**Comments on Responses
Submitted for Deadline 3**
on Behalf of the
**Neighbours and Users of
Queen Elizabeth Park**

Interested Party reference no: **20022545**

1. General Arrangement Plans (3 of 3)¹

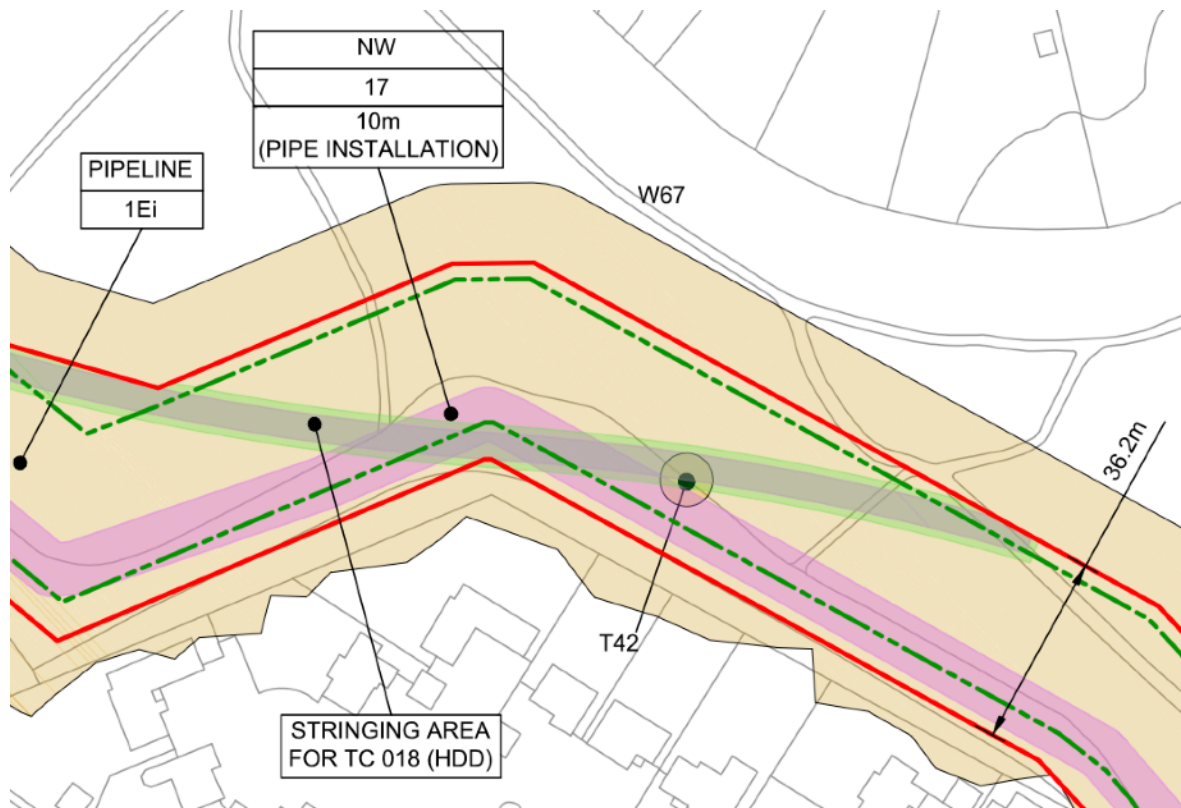
1. This is not satisfactory because it does not show how individual trees might be affected by the working areas (this would have been known when providing the response to action point 7 from ISH 2).
2. Trees which were listed on the Woodland Trust's Ancient Tree Inventory at the time the plans were produced should have been included.
3. Preliminary results of Esso's tree survey would also have been available (these even seem to be shown in Figure 1.4 on page 72 of Esso's Responses to Written Representations - Other Parties).

The plans do not make best use of the information available at the time they were produced.

We understand that Esso's tree survey must be submitted at Deadline 4, so we expect the next revision of the General Arrangement Plans to show the required details.

1.5. Drill and Receptor Pits

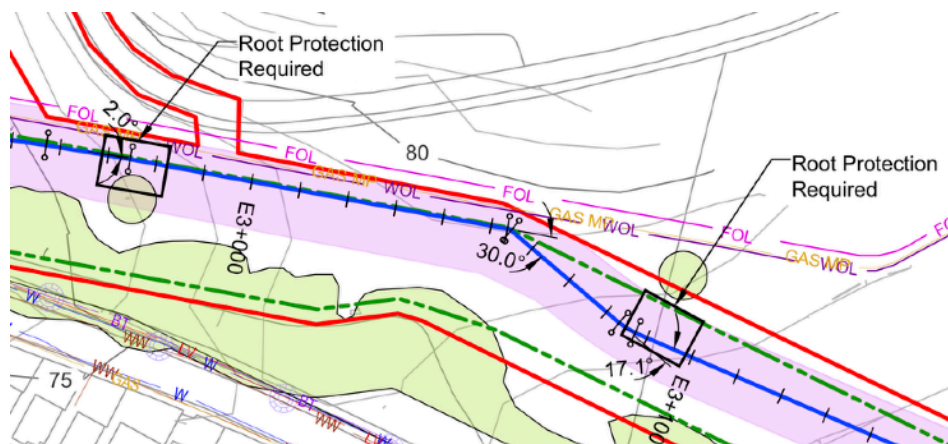
1. No drill or receptor pits are shown within Queen Elizabeth Park.
2. We realise that these pits are not themselves within a narrow working area but they are in a known hotspot and they directly adjoin a narrow working area.

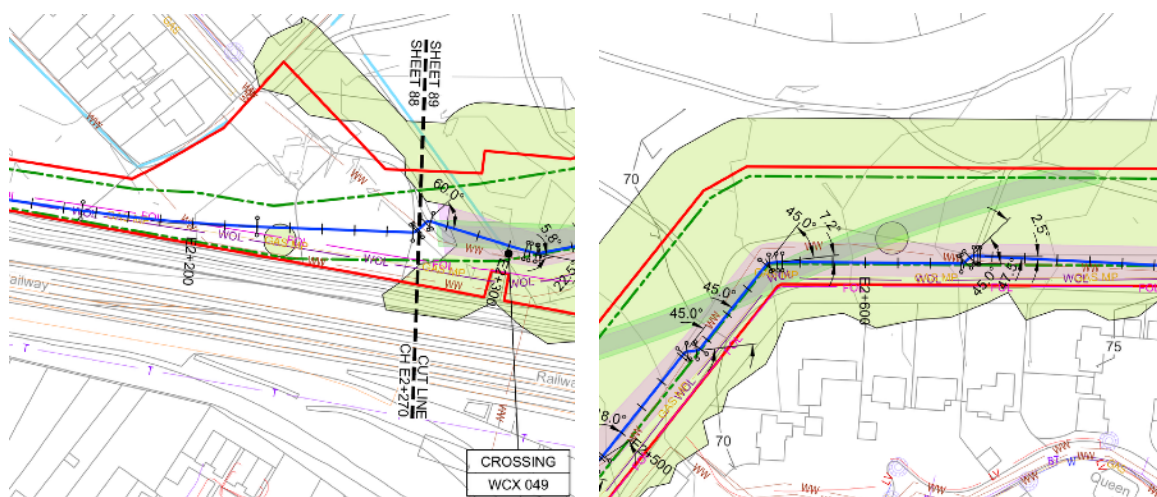
Sheet 90 shows root protection areas in the narrow working area near trees in Farnborough Hill School grounds:

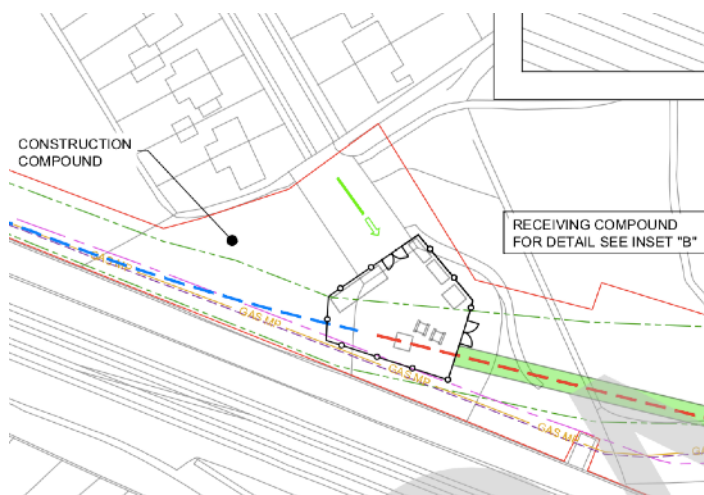
No such areas are shown next to the two individually indicated trees (T41 and T42) in Queen Elizabeth Park on sheet 89:

T41 is the circle at the centre of the extract on the left, T42 is the circle in the same position on the right.

1. There seem to be no plans to protect the root areas of T41 and T42.
2. There are no plans to protect root areas of any other trees in the park.

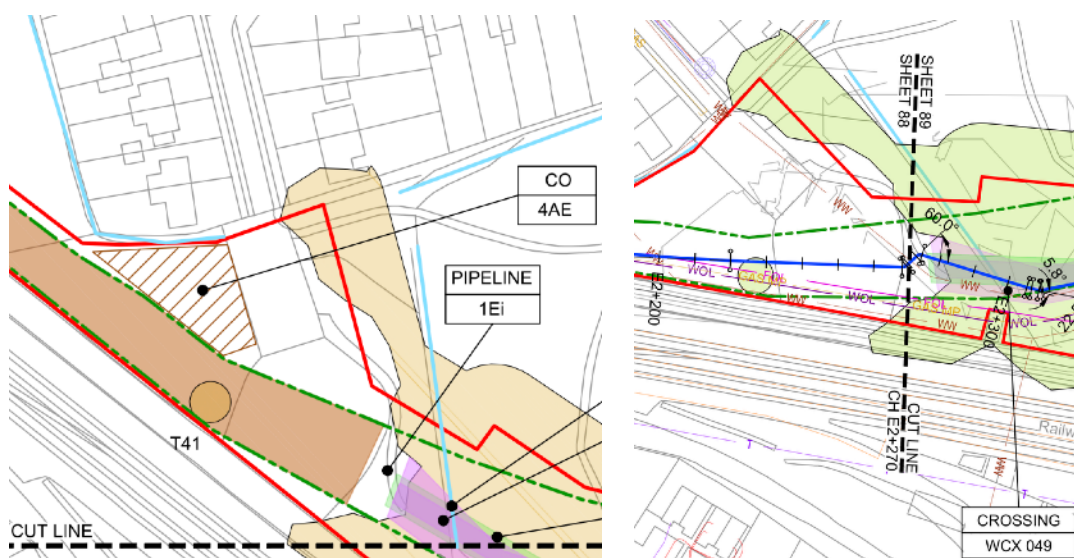
The drawing for TC018 omits Tree T41. This is a notable tree from Esso's list which is near the Queen Elizabeth Park play area. It is situated within the HDD limits of deviation.

T41 is shown in the General Arrangement Plans on sheet 105 (below left) and in the Alignment Sheets (narrow working) on sheet 89 (below right).

This tree is also absent from the longitudinal section (A-A) of the TC018 drawing.

1. T41 is in the section where the bore rises to enter the reception pit and therefore it is at risk of root damage.

2. The works are within the root protection area of the tree.
3. As a minimum, Esso's Technical Note on Ancient Woodland and Veteran Trees commits to mitigation B3, specialist techniques, e.g. hand digging.
4. Hand digging within a tree's root protection zone is the most invasive of the three mitigation categories. However, in this case, a rising HDD bore is being driven through the root zone, which is far more invasive and destructive.

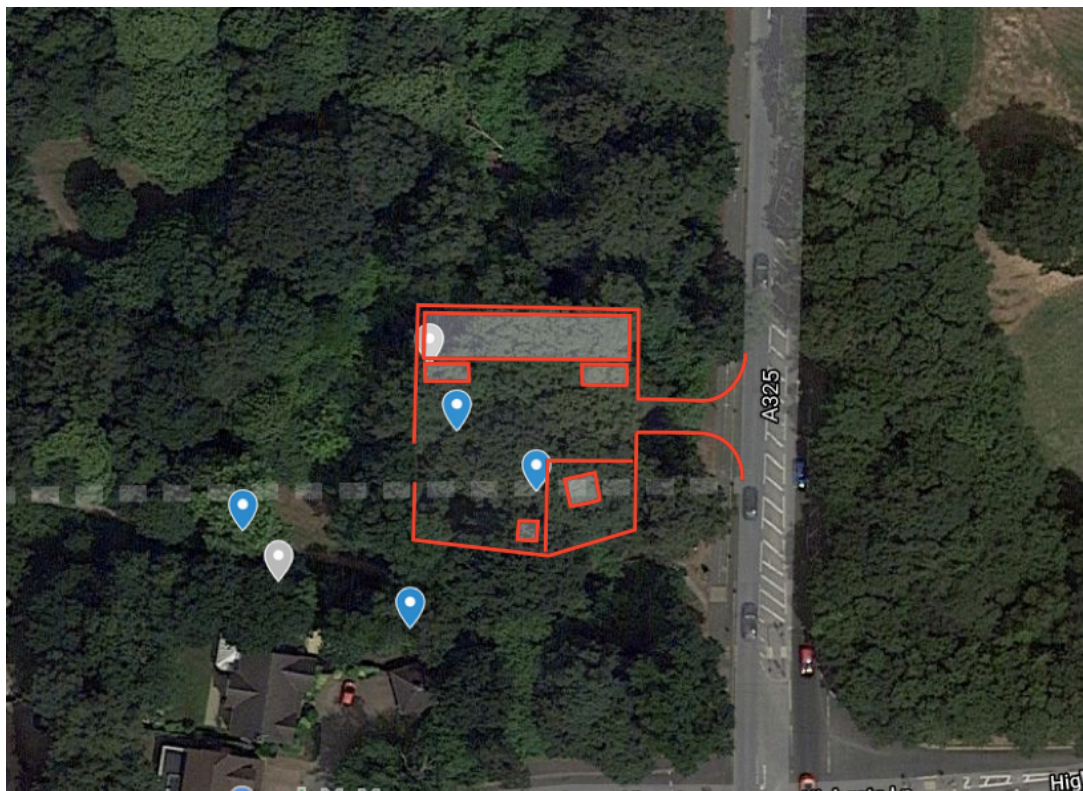
Esso's comment: *'the Applicant has positioned the drive pit and reception pit compounds so as to reduce tree loss ... The Applicant can position equipment in and around the larger trees and anticipates that vegetation clearance in both areas can be kept to a minimum.'*

This ignores root protection zones. We would also be very interested to know which equipment Esso plans to position **in** the trees. We are unable to think of any construction equipment which would benefit from such placement, and are concerned about the potential damage it could cause to the trees.

The comments about the anticipated extent of tree removal are contradicted in Esso's response to paragraph 2.4.1 on page 63: *'The area for the trenchless crossing of the A325 will require greater tree removal in comparison [to the narrow working area].'*

By overlaying Esso's diagram from Figure 1.5 on an aerial view of the park, it is easy to see that significant tree removal will be required, including two notable trees (marked in blue). Even if all trees are retained there will be major disruption in their root protection zones.

(The grey dotted line is Google Maps' representation of the footpath. This does not represent the true position of the footpath: it does not run through the proposed compound.)

With the layout shown above, it does not seem to be feasible to operate the working area in a satisfactory manner without removing trees. For example, one of the notable trees will prevent the backhoe/excavator from rotating anti-clockwise from the reception pit to unload its bucket into a wheeled dumper for transport to the topsoil stockpile. It is difficult to envisage a safe, working compound with the trees still in place.

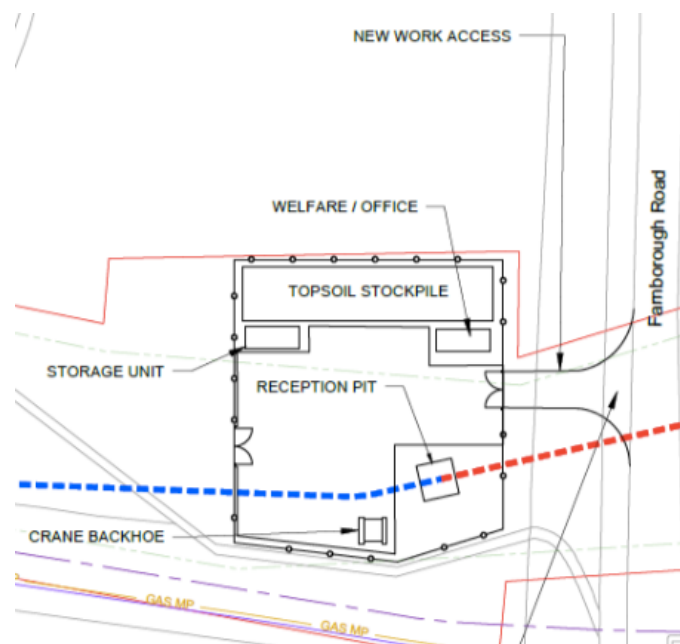
The structure shown in Esso's Figure 1.5 shows that the previously proposed auger boring pit has now grown to become an additional compound in the park, with storage and welfare facilities.

1. Until Deadline 3, Esso's plans had indicated that only one compound would be present in the park. Now, with the addition of this compound and the one around the Stake Lane reception pit, there are three compounds.
2. No generator is shown yet this compound contains a welfare/office facility.
3. The possible presence of a generator - and its location - are particularly pertinent details due to the close proximity of this compound to number 25 Queen Victoria Court.

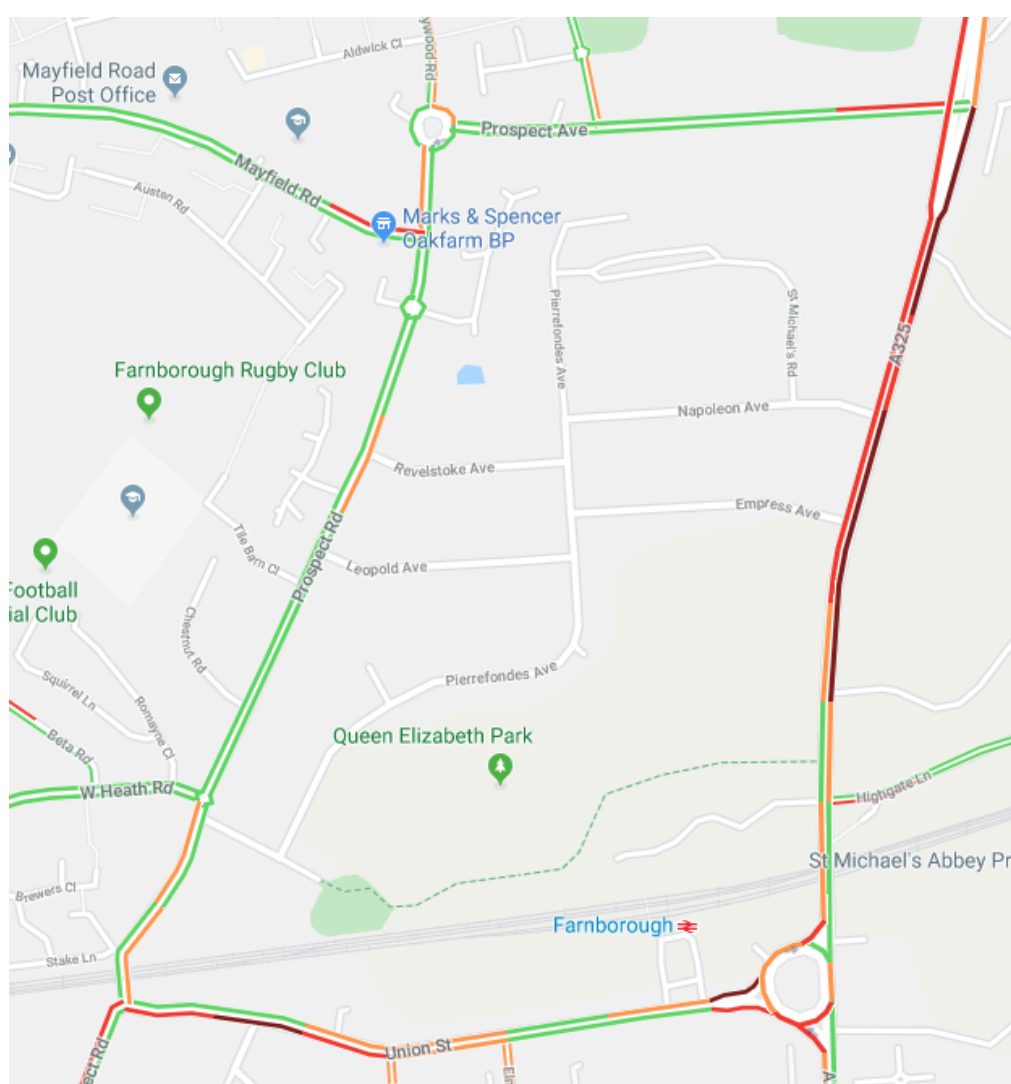
Esso's Figure 1.1 (reproduced below) shows three compounds in the park (circled):

We believe that the leftmost compound on the plan, indicated by the hatched area, is identified as Work No. 4AE in the dDCO.

Two additional compounds are shown, which were previously referred to as drill pits, for example, in Esso's Queen Elizabeth Park Information Sheet¹⁷. As the plans in Esso's Figure 1.1 show, these drill pits are now compounds and contain far more extensive facilities than originally indicated.

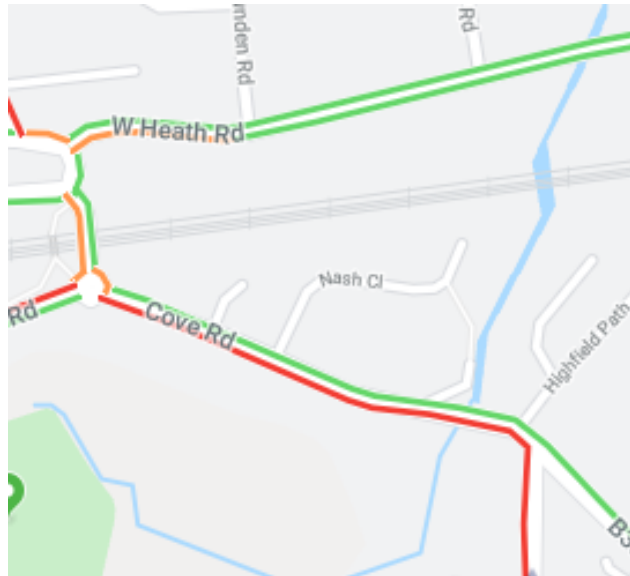
In fact, traffic levels on Prospect Road and Prospect Avenue levels are typically light, as can be seen from Google Maps, showing traffic load at 17:30 on a Tuesday evening.
